Reference Number: N162039440

Release Date: February 2018 Revision: 02

Revision Description: The Service Procedure and the Warranty Information sections have been revised. Effective immediately, technicians MUST record the Warranty Claim Code on the Job Card. To avoid warranty transaction rejection, this information must be entered when submitting the transaction. If the Same Calibration/Software Warning is noted on the SPS Controller screen, continue with the programming event using SPS to ensure a Warranty Claim Code is displayed on screen. Please discard all copies of bulletin 39440-01.

F/CMVSS Noncompliance Recall 39440 Electronic Brake Control Module Memory Failure

4919539

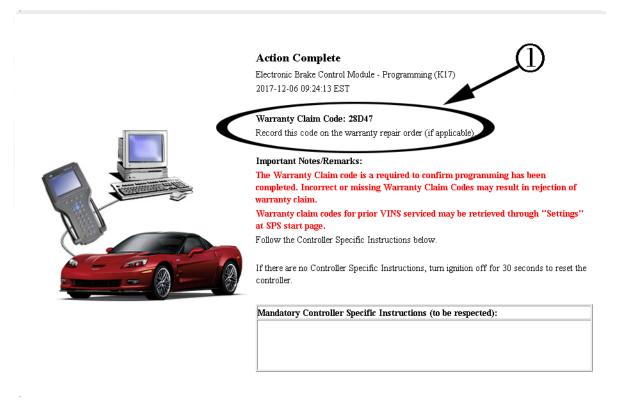
Note: If the Same Calibration/Software Warning is noted on the SPS Controller screen, continue with the programming event using SPS to ensure a Warranty Claim Code is displayed on screen. Technicians MUST record the Warranty Claim Code (1) on the Job Card. To avoid warranty transaction rejection, this information must be entered when submitting the transaction.
